APPLICATION FOR IMPROVEMENT PERMIT FOR RESIDENTIAL SITE INDIVIDUAL WATER AND WASTEWATER SYSTEMS PROGRAM

Subject: Application for Improvement Permit for Residential Site
Individual Wastewater System - 10043 Idlewild Road
William H. Cooper, Owner Hossein Nikrooz, Buyer

CONDITIONS OF IMPROVEMENT PERMIT

SOIL/SITE EVALUATION for ON-SITE WASTEWATER SYSTEM

PROPOSED PLOT PLAN

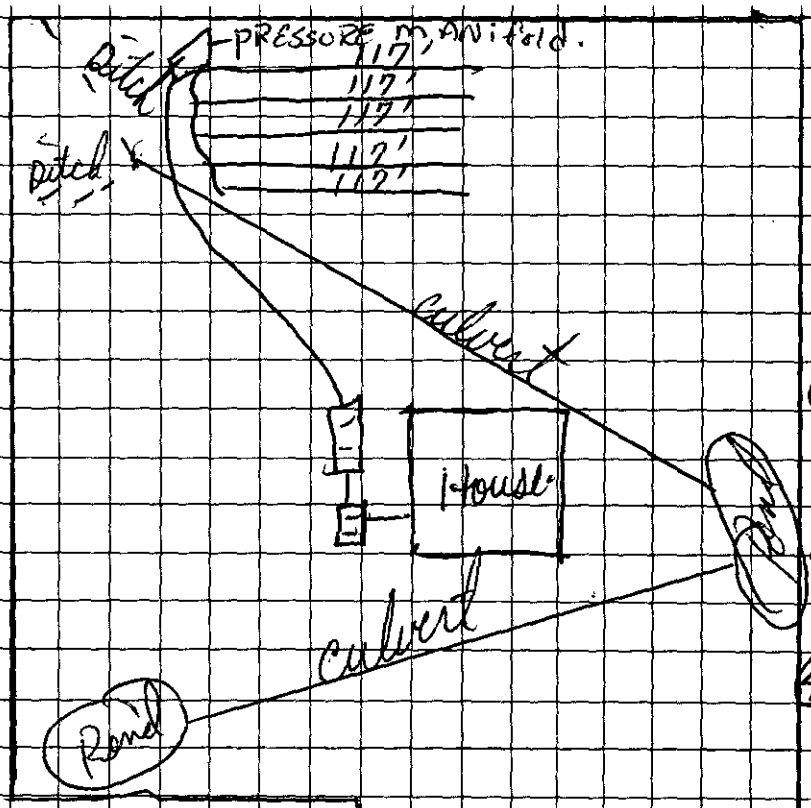
① Not to scale.

② 581 Linear feet of Drain line Conventional

③ Type II system designed for a (4) bedroom design unit.

④ Keep lines level & on contour

⑤ Stay > 5' off house > 10' off property lines w/ system.

⑥ 5 year III B inspection requirements must be met.
